### THM 4L60 (700-R4) REDESIGNED 3-4 CLUTCH PACK

**CHANGE:** Beginning on January 5, 1993 (Julian Date 005) all THM 4L60 and 4L60-E transmissions

Figure 1
AUTOMATIC TRANSMISSION SERVICE GROUP

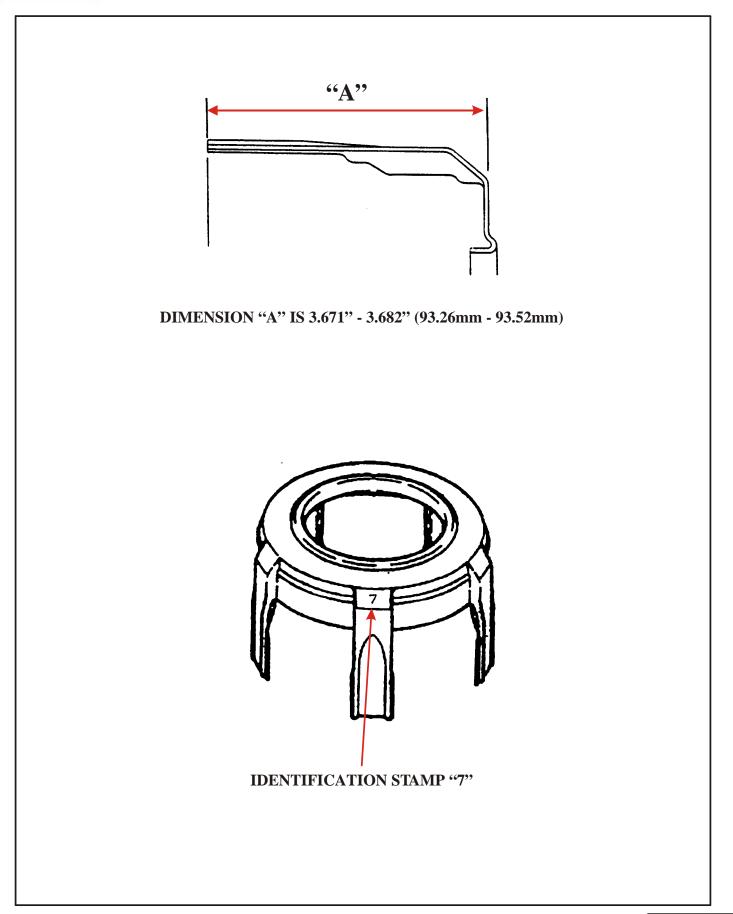
- (1) 3-4 CLUTCH APPLY RING The legs on the apply ring were made shorter to accommodate the thicker 3-4 clutch steel plates. The new design 3-4 clutch apply ring is identified with the number as shown in Figure 1. "7" stamped on one of the legs
